**TOWN OF HERNDON, VIRGINIA
PLANNING COMMISSION PUBLIC HEARING AGENDA
MARCH 25, 2019
HERNDON COUNCIL CHAMBERS BUILDING
765 LYNN STREET
7:00 P.M.**

Subject: Proffer Condition Amendment Application, PCA#19-01, 525 Grove Street

RE: Vertical Bridge US-VA-5060 – Herndon Substation
525 Grove Street
Proffer Condition Amendment #19-01 - **Revised**

PROFFERS**“Generalized Development Plan, US-VA-5060 Herndon Substation”****PCA #19-01****Amendment to ZMA-02-102****February 26, 2019**

C-1
SHEET 4 OF 7

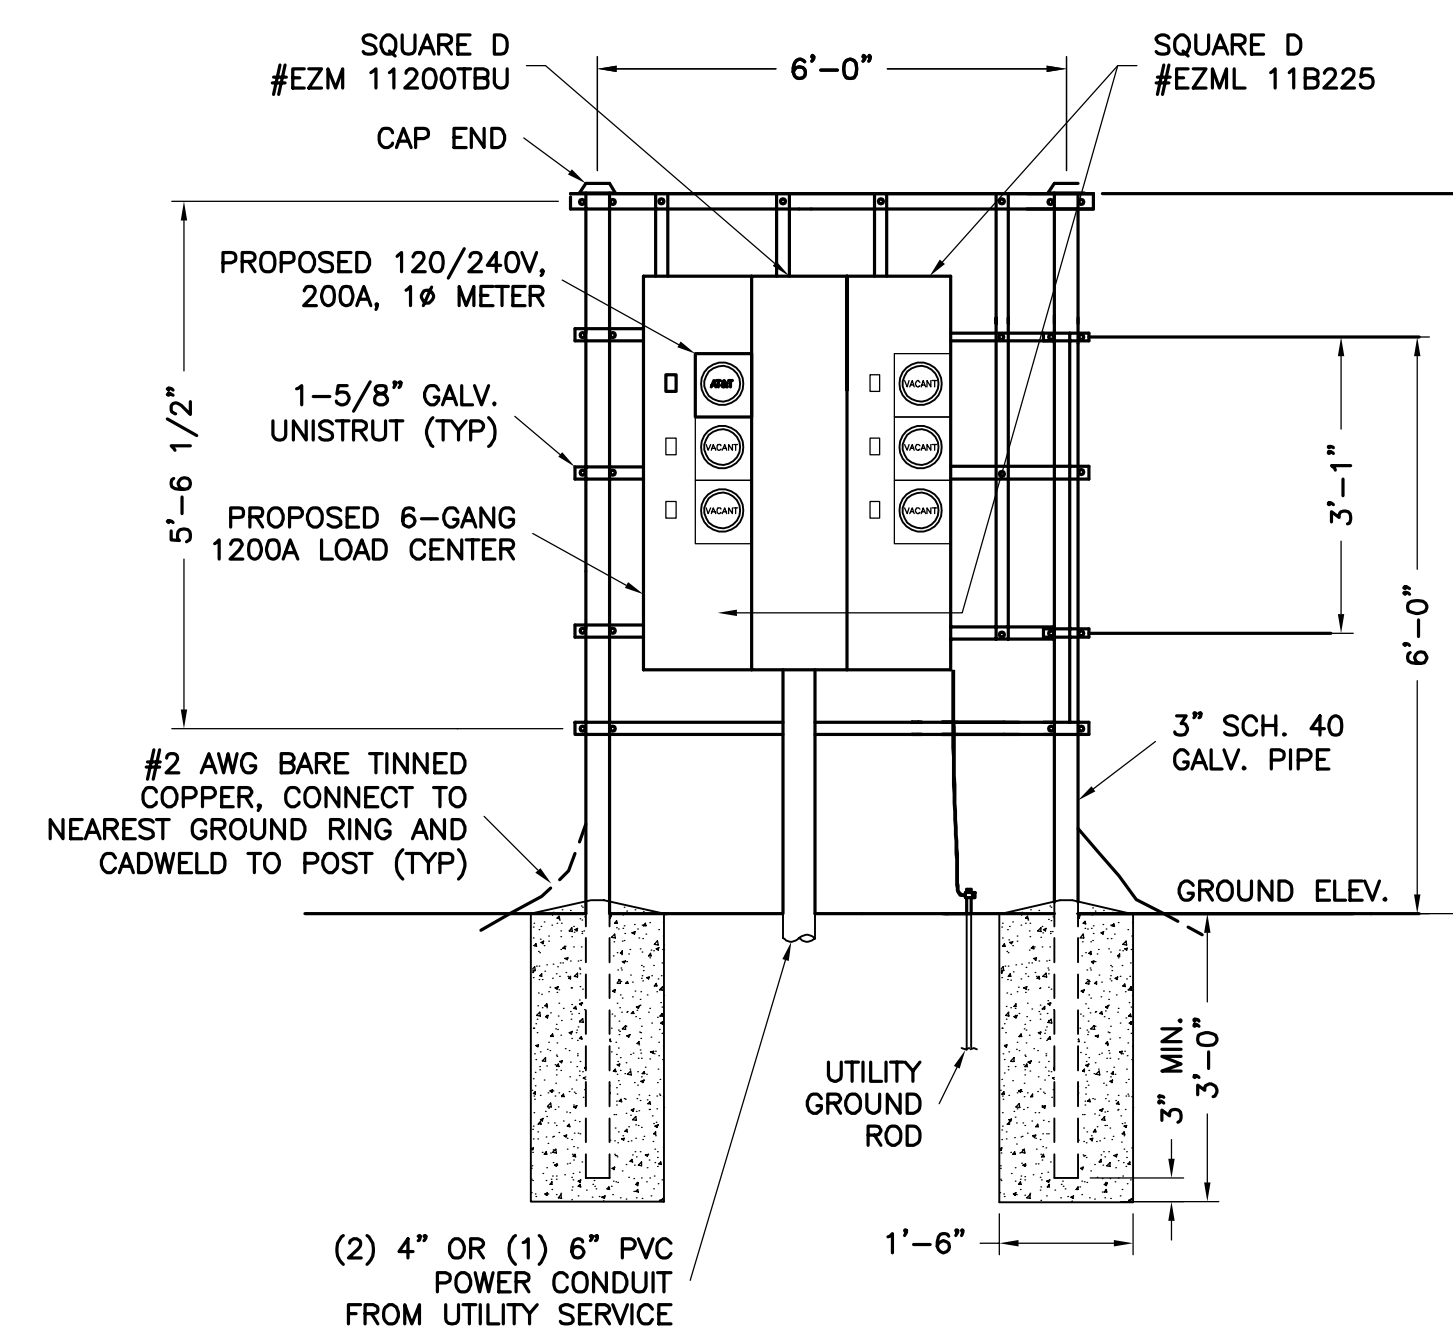
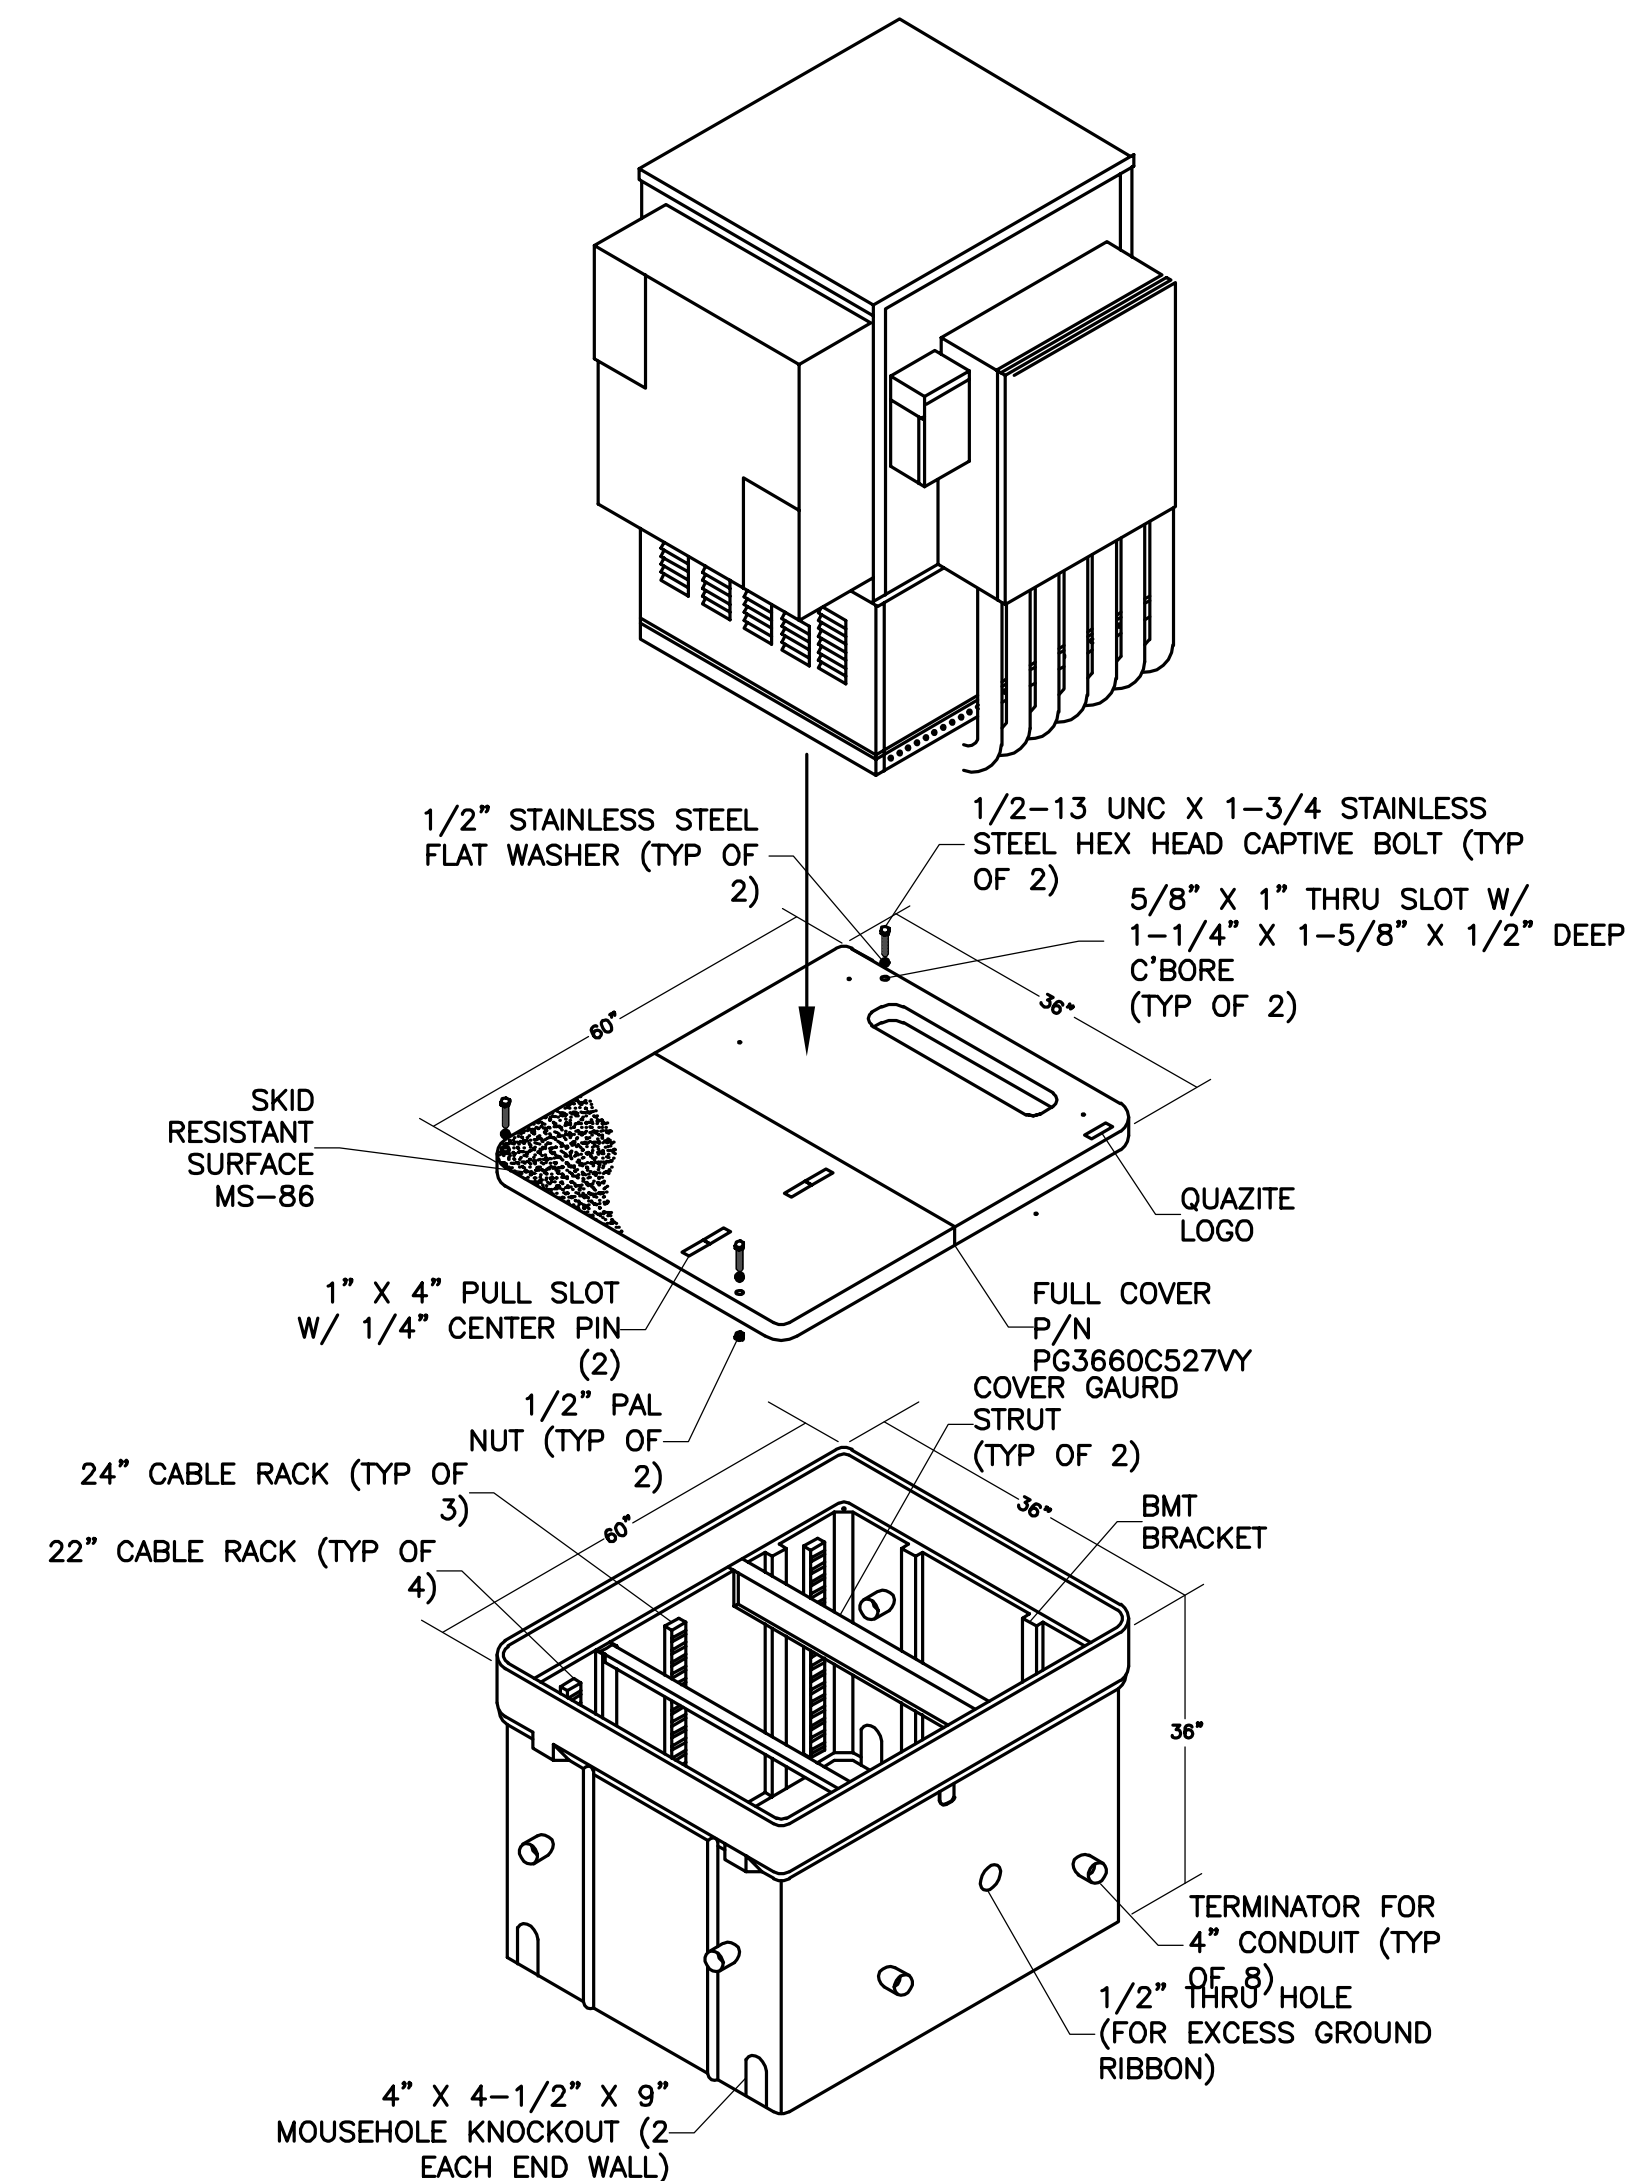
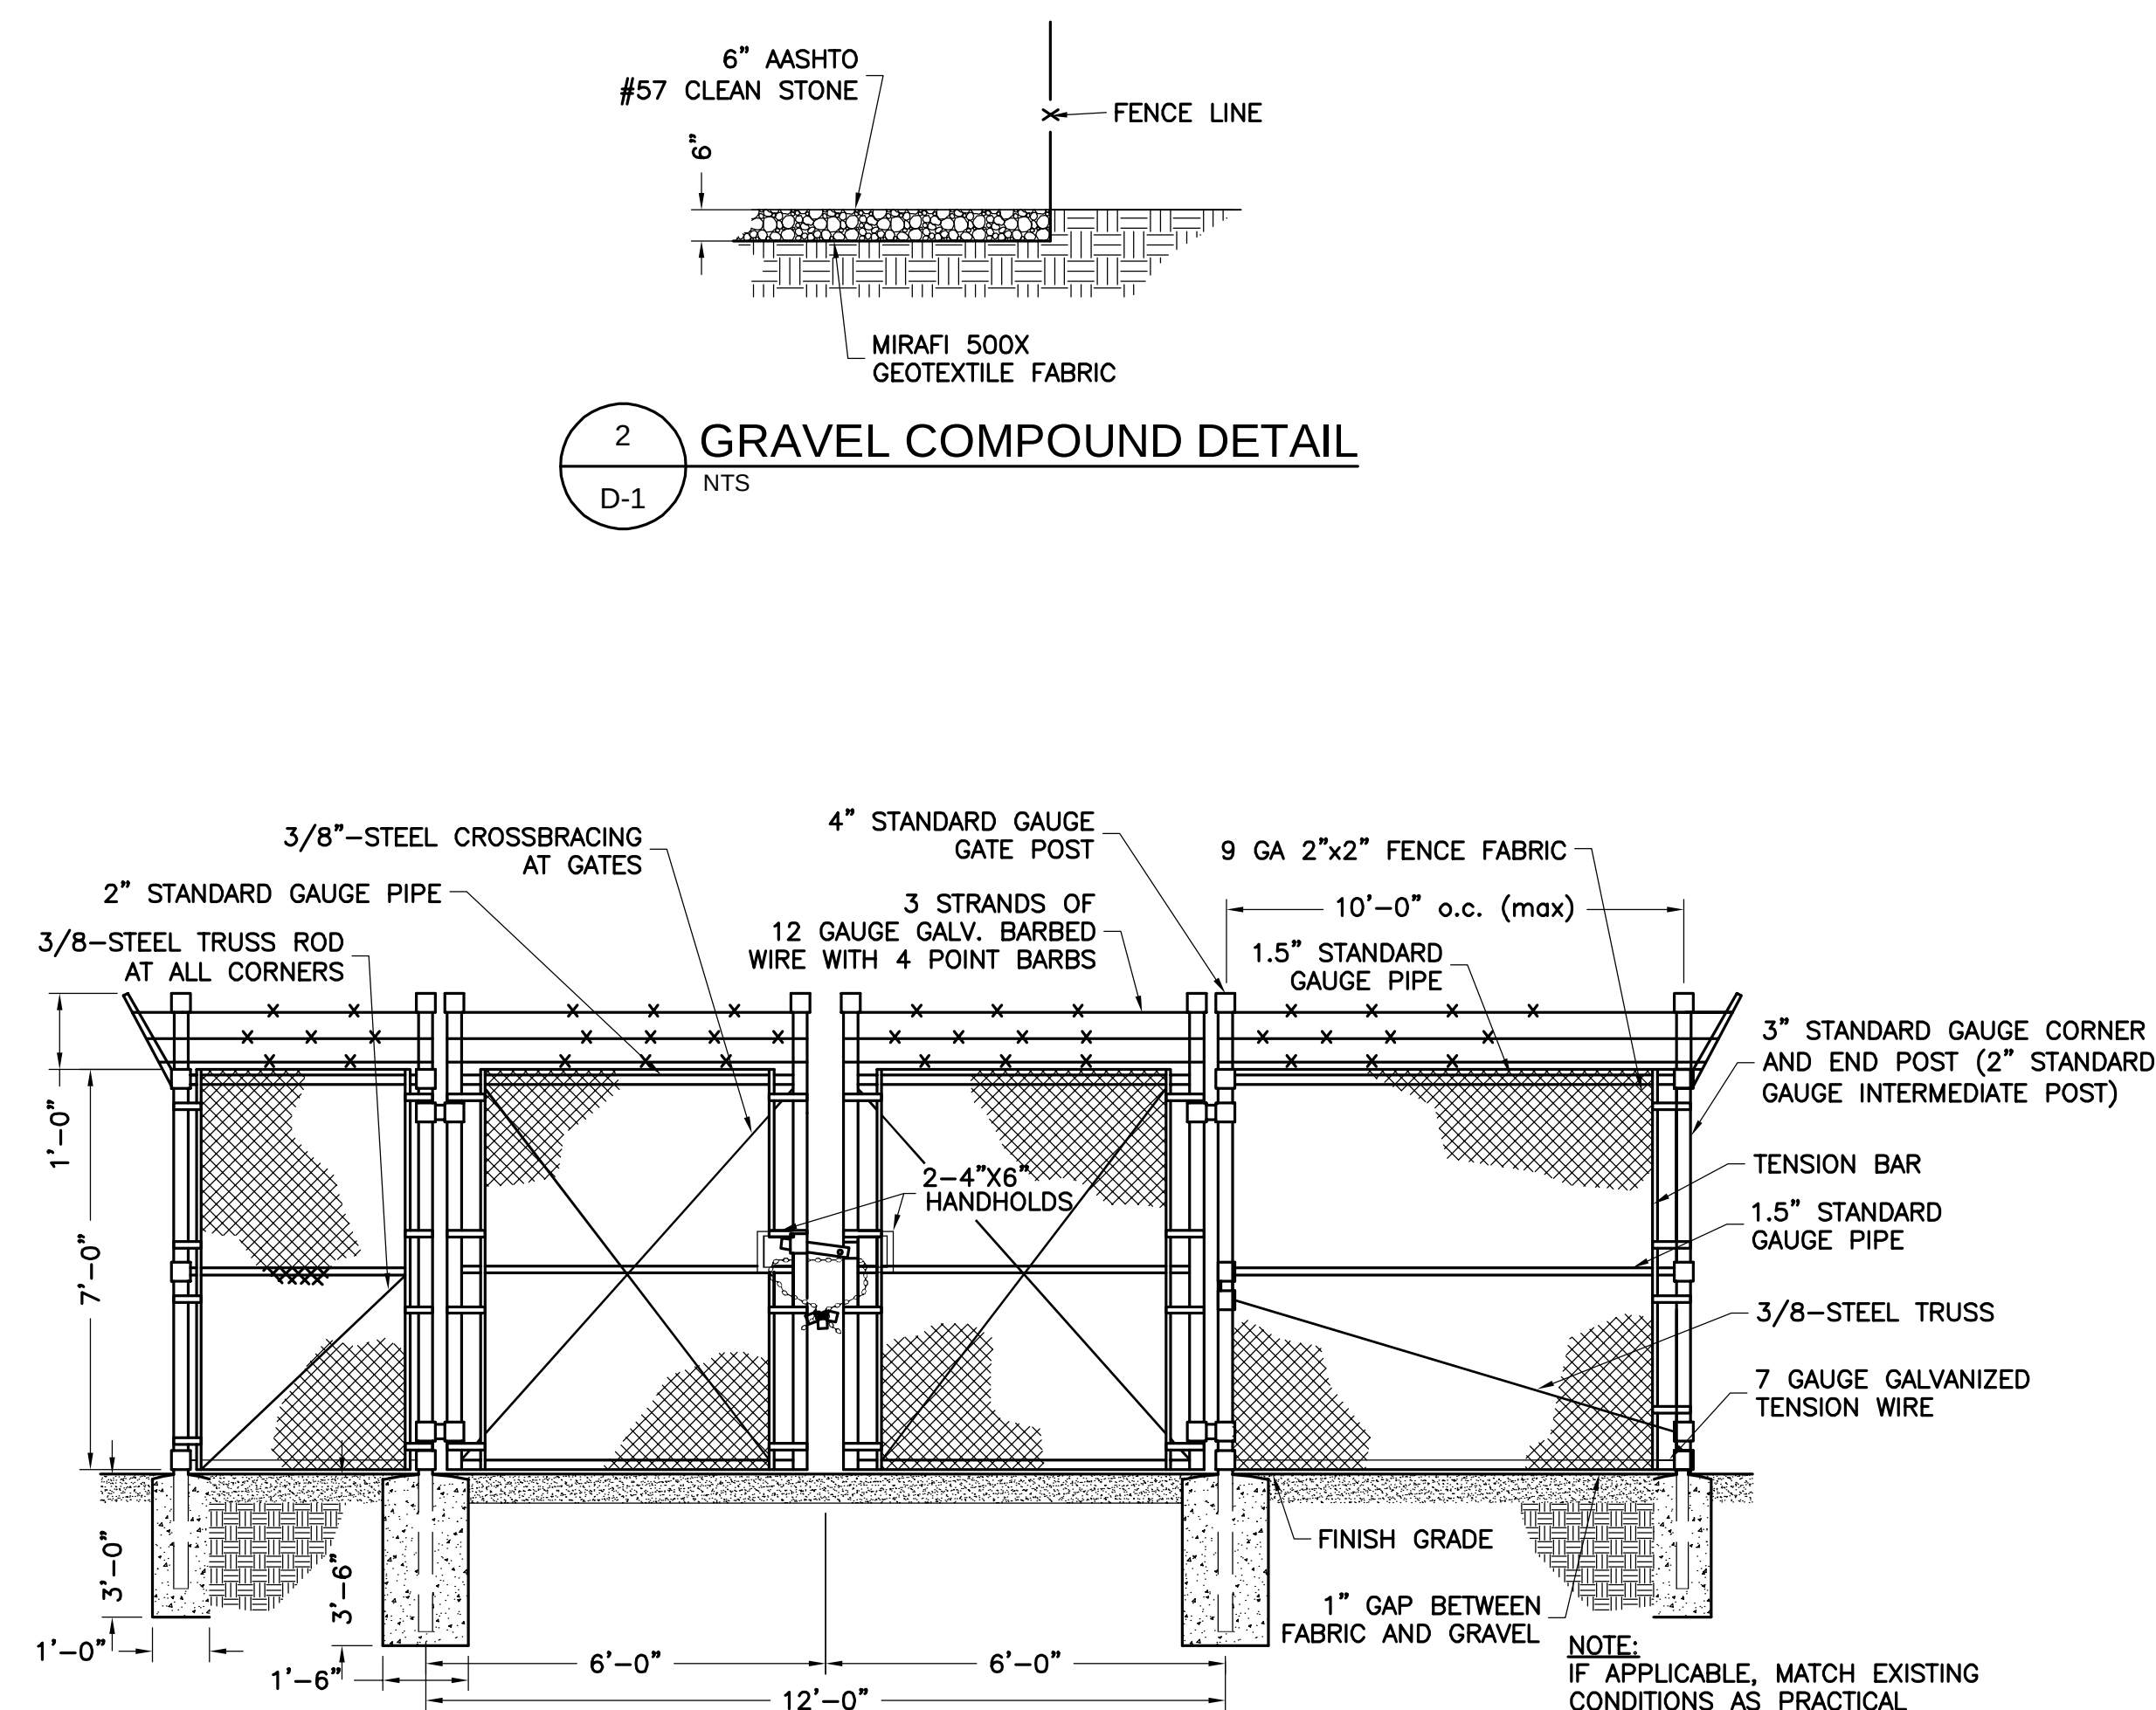
9. Fence elevation on sheet C-1 indicates two gates. This does not match with the proposed plan on sheets Z-1 and Z-2. It is recommended that only one gate be installed and with direct connection on-site to the internal access road.

The fence detail has been revised to shown just one gate. However, applicant objects to any limitation on the ability for an additional gate(s) to be added in the future, if it might allow better access in and around the compound by carriers who may collocate on the proposed tower. The gates are for pedestrian access, not vehicular access, and vehicular access has been adequately limited the gravel driveway along the north side of the property.
